## PCI-SIG ENGINEERING CHANGE NOTICE

<b>TITLE:</b>	Generic Capability Structure for SATA Host Bus Adapters
<b>DATE:</b>	October 17, 2004
<b>AFFECTED DOCUMENT:</b>	PCI 3.0
<b>SPONSOR:</b>	Robert Strong, Intel

## SATACR - Serial ATA Capability Register

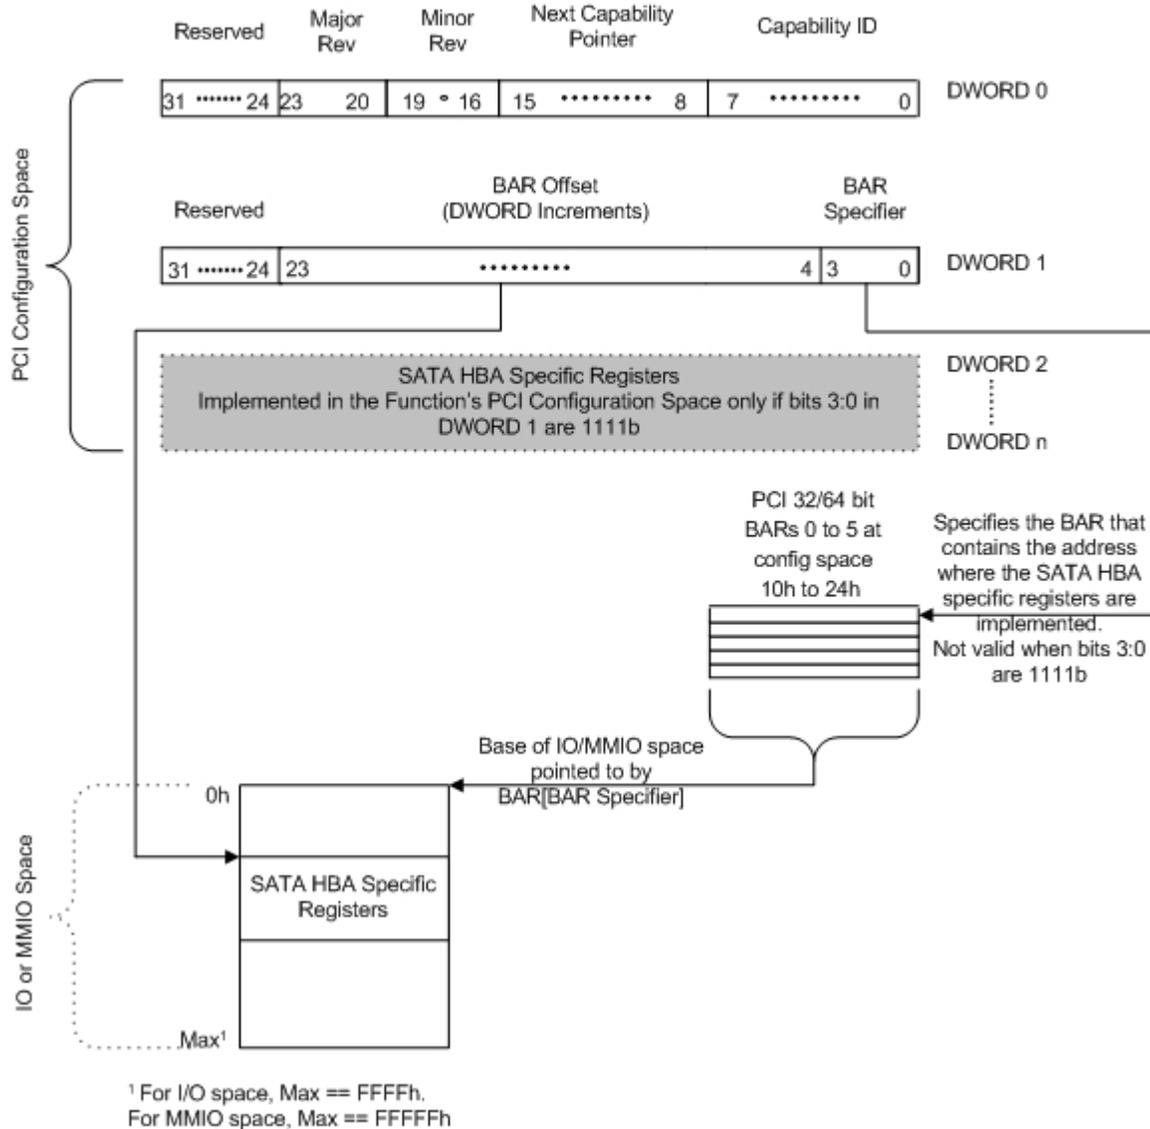
The functional changes proposed involve the definition of a new Capabilities List ID (and associated Capability register set). This new Capabilities ID will identify to system firmware (BIOS/OROM), a Serial ATA (SATA) host bus adapter's (HBA) support of optional features that may be defined in the particular SATA HBA specification (i.e. Advanced Host Controller Interface - AHCI). ***It is important to note that this capability register is intended for use by pre-boot software that may not have the ability to access SATA HBA specific MMIO registers that reside above 1MB. OS specific device drivers do not have this limitation and are expected to determine optional SATA HBA features through an examination of the HBA's specific capability register, which may be found in IO or MMIO space – this is SATA HBA specification dependent.***

*The capabilities provided by the SATA HBA are HBA specification specific; it is the responsibility of the system firmware to comprehend the exact implementation. The following outlines the format of the new Capability register:*

**Bits [7:0] – PCI SIG assigned Capability ID.** This SATA HBA feature has been assigned a Capability ID of 12h.

**Bits [15:8] – Pointer to Next Capability.** Specifies the offset into PCI configuration space where the next Capability pointer resides.

**Bits [19:16] – Minor Revision.** Specifies the minor revision level to which the capability register is built. This may differ across SATA HBA implementations and is SATA HBA specification specific.

**Bits [23:20] – Major Revision.** Specifies the major revision level to which the capability register is built. This may differ across SATA HBA implementations and is SATA HBA specification specific.

**Bits [31-24] – Reserved.** Must return zero when read.

**Bits [3:0] – BAR Specifier.** Specifies which IO/MMIO space BAR in the function's PCI configuration space contains the SATA HBA specific registers. These bits represent an absolute offset (DWORD increments) into the device's PCI configuration space. These bits are read-only and may be assigned one of the following values:

**Bits [23:4] – BAR Offset.** Specifies the offset (DWORD increments) into the IO/MMIO space BAR where the SATA HBA specific registers are located. These bits are read-only and may be assigned (by hardware) the following range of values:
